To:
Company: Auckland Council
From: Pierre Verhaeghe
Date: 14 April 2026 Project No: 145828.16
Subject: Downtown Carpark Site Development | Environmental Winds | S67 RFI

This memorandum is in response to the Wind item #34 of Section 67 RFI document from Auckland Council dated 26th March.

Figure 1: Wind Conditions in Area 1

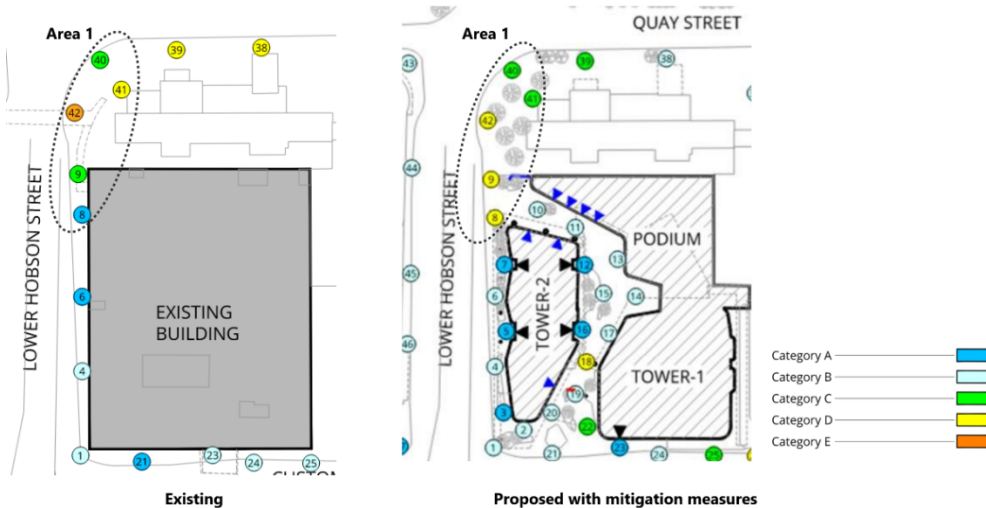
- *AREA 1 (Sensor 8-9): Lower Hobson Street – North-west corner of P2.* Category D conditions are similar (or even calmer) to the existing conditions currently occurring slightly further north (Sensor 42). The effect of the proposed Development is therefore to shift the existing area of peak windiness occurring near M-Social slightly further south, closer to the corner of P2. In other words, the increase in windiness around Podium P2 is balanced by a reduction of windiness around M-Social (Sensor 42 and 41).

Alternative mitigation measures have been assessed in several wind tunnel tests and in collaboration with the design team, as reported in Appendix A of the Holmes report. It was clearly established from that testing that larger canopies or other potentially feasible measures on site were not found to be effective in improving conditions in Area 1 further. Wind mitigation measures need to be positioned at the north end of Lower Hobson.

Figure 2: Wind Conditions in Area 2&3

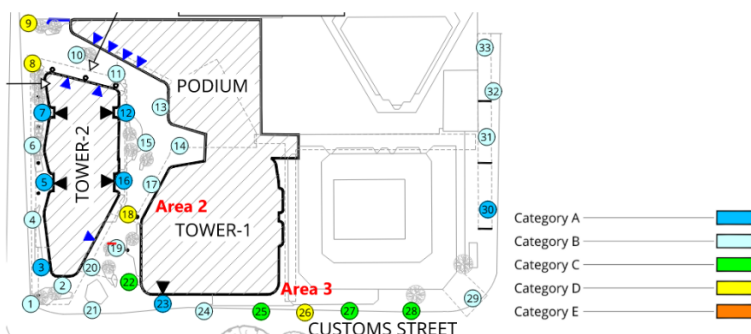
- AREA 2 - Throat between P1 and P2 (Sensor 18).** The conditions are categorised as Category D but the exceedance of the threshold is marginal only, i.e. conditions are almost in Category C. These conditions are local only, i.e. conditions either side of the throat improve significantly. We also confirm this area is for pedestrian transit and is not considered sensitive for comfort. Again, various additional screens were investigated with no effect (Appendix A of Holmes report). Our conclusion was that only further screens specifically located at the throat would improve conditions more, which would not allow pedestrians' movement, and therefore were not feasible.

- AREA 3 – P1 south-east corner Custom Street (Sensor 26).** The Category D area is very local and conditions immediately either side (Sensor 25 and 27) are in Category C. This is not considered a significant effect, given that the use of this footpath space is for walking only.
